# Wisconsin Department of Transportation

**Proposal #21: 1517-07-80, WISC 2016 481  
 USH 10 – USH 10/STH 441  
 County CB – Oneida Street  
 USH 10  
 I-41 Interchange Ramps  
 Winnebago County**

**Letting of December 13, 2016**

This is Addendum No. 01, which provides for the following:

COVER PLATES FOR PARAPETS  
SHEET 42 OF 47  
683

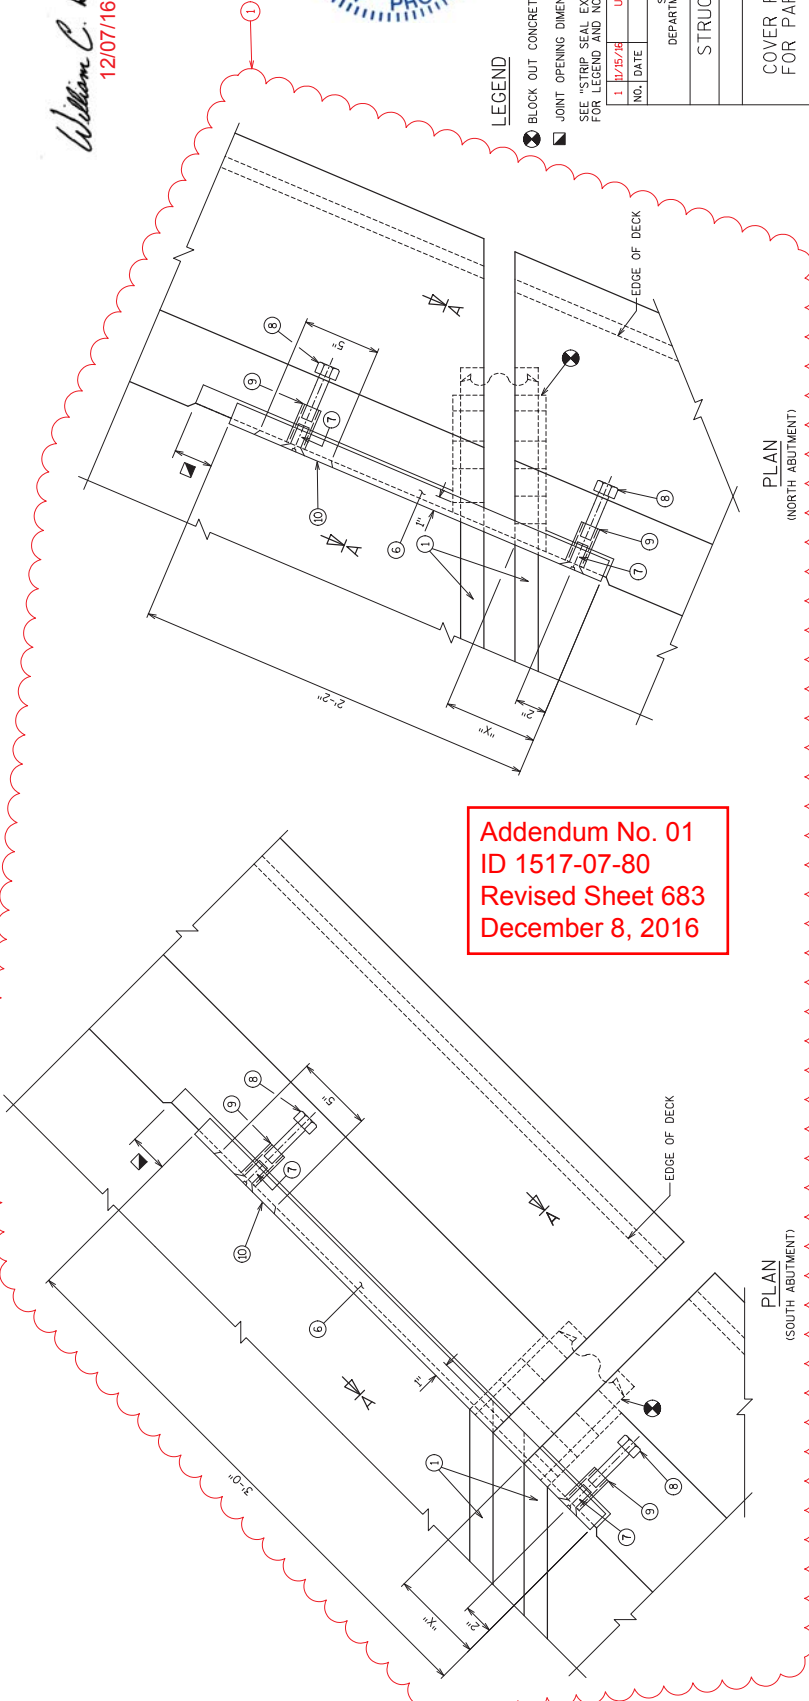
683	B-70-407, Cover Plated For Parapets (Added plan view)
685	B-70-407, Aesthetic Details (Changed girder color to hopsack)
686	B-70-407, Downspout Details (Updated callouts and notes)
687	B-70-407, Slope Paving (Crushed Aggregate) (Updated sheet title and depth)
689	B-70-409, General Plan (Updated slope paving callout)
690	B-70-409, Quantities & General Notes (Updated quantities and general notes)
693	B-70-409, West Abutment (Updated slope paving callout)
695	B-70-409, East Abutment (Updated slope paving callout)
733	B-70-409, Slope Paving @ West Abutment (Updated slope paving depth and callout)
734	B-70-409, Slope Paving @ East Abutment (Updated slope paving depth and callout)

Addendum No. 01  
ID 1517-07-80  
Revised Sheet 683  
December 8, 2016

NO.	DATE	REVISION	BY
1	12/7/16	UPDATED PLAN VIEWS	JDL

SHEET 44 OF 47  
**685**

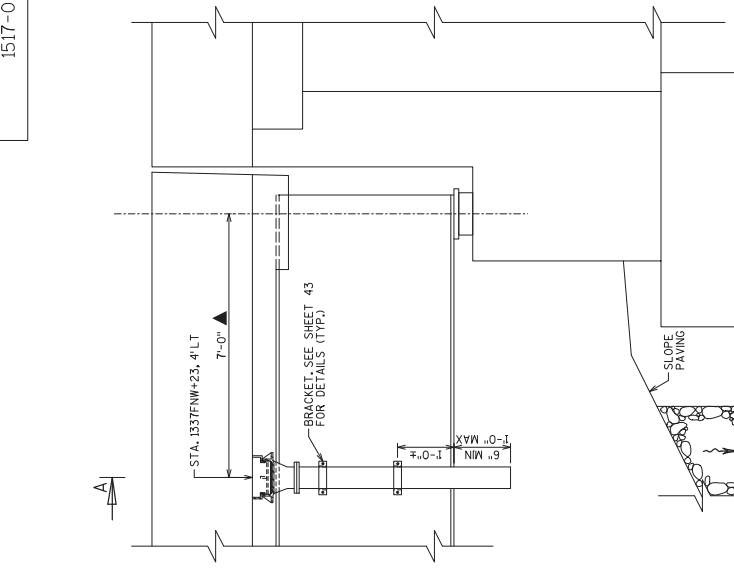
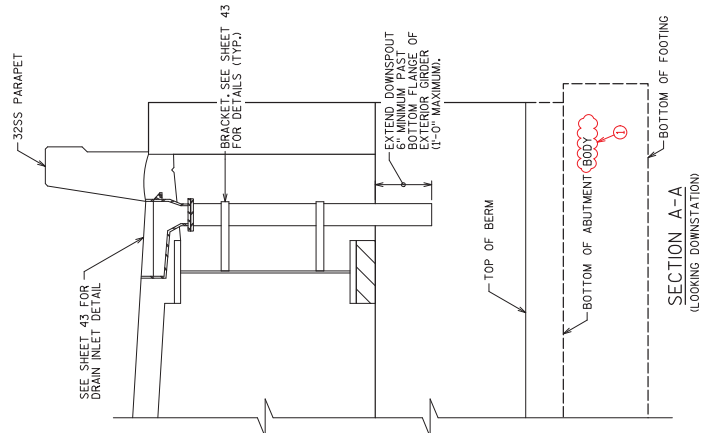
**Addendum No. 01**  
**ID 1517-07-80**  
**Revised Sheet 685**  
**December 8, 2016**

NO.	DATE	REVISION	BY
1	12-23-16	REVISED CALLOUT & NOTE	DNU/JDL

1	11/23/16	UPDATED DEPTH	JDL
NO.	DATE	REVISION	BY
STATE OF WISCONSIN DEPARTMENT OF TRANSPORTATION			
STRUCTURE B-70-407		DESIGNED BY	JDL
SLOPE PAVING (SELECT CRUSHED MATERIAL)		PERKINS	JDL
		SHEET 46 OF 47	687

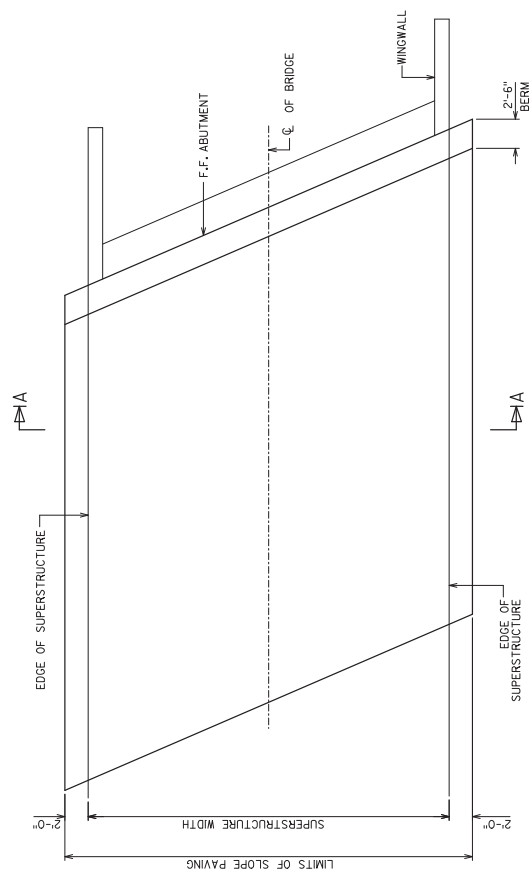
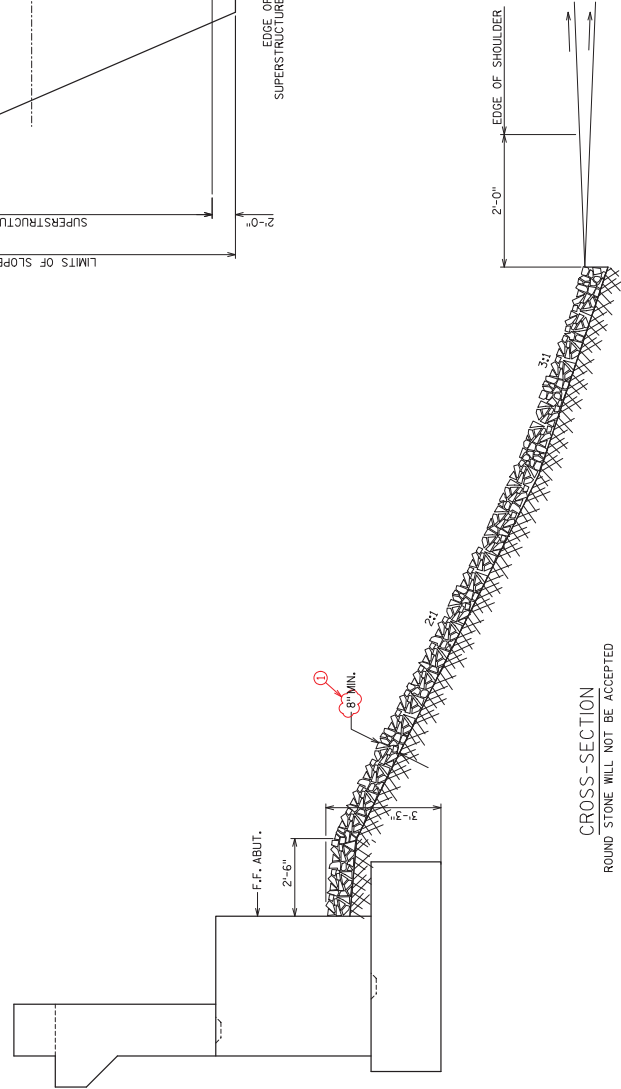
Addendum No. 01  
ID 1517-07-80  
Revised Sheet 687  
December 8, 2016
